Service Bulletin

Bulletin 2007-27-ABDE

SUBJECT: Defective High-limit Thermostat

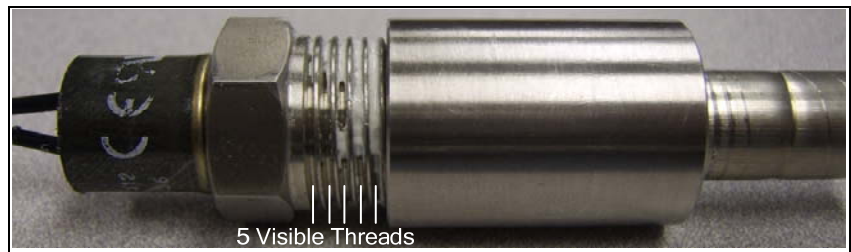
Due to vendor error, a number of high-limit snap disc thermostats have been found to be defective. The ½" NPT male threads are too large and will not properly seal in the ½" NPT couplings. The defective high-limit thermostats will only screw into a ½" NPT coupling approximately ¾ of a turn by hand. A good high-limit will screw into a ½" NPT coupling a minimum of 3 turns by hand.

"Good" part.

"Defective" part.

Defective high-limits should be sent back to Frymaster for credit and replacement.
